SUBJECT: NONCOMPLIANCE RECALL (U.S., EXPORT)

Park Brake Relay Valve on 7400, 7500, and 7600 Models with Air Brakes built 2/8/2004 through 2/25/2004

Figure 1 – Approximate Frame Location of Park Brake Relay Valve

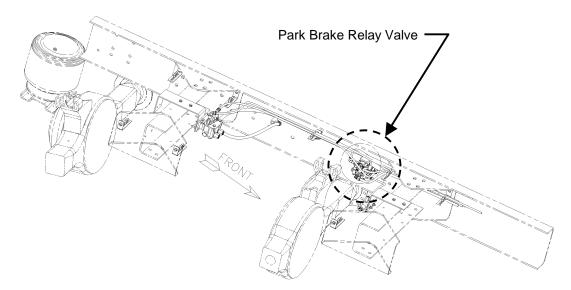
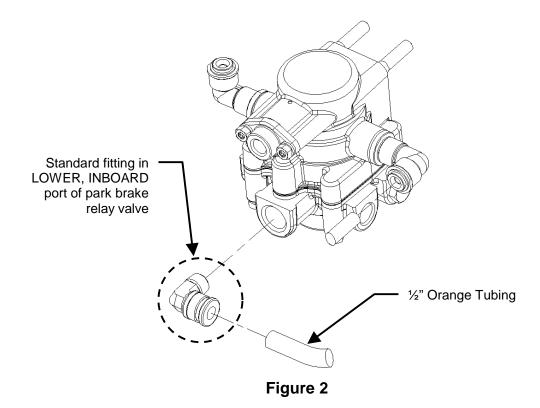
A standard fitting was installed in place of a single check valve on the park brake relay valve. A single point failure of either the primary or secondary air circuits will cause the entire air system to bleed down. If this happens, there will not be enough air in the system to disengage the park brakes.

2. Locate the park brake relay valve (see figure 1) and disconnect the 1/2" orange tube from park brake relay valve that contains the standard fitting.

Figure 3

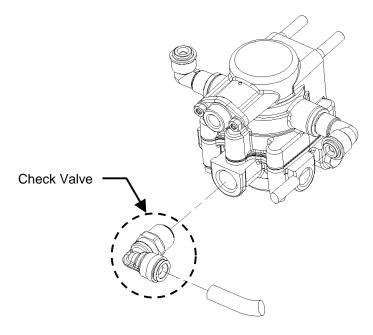
3. Remove the standard fitting from the *LOWER*, *INBOARD* (see figure 2) port of the park brake relay valve.

4. Install check valve in place of standard fittings. Orient check valve towards the front of the vehicle.
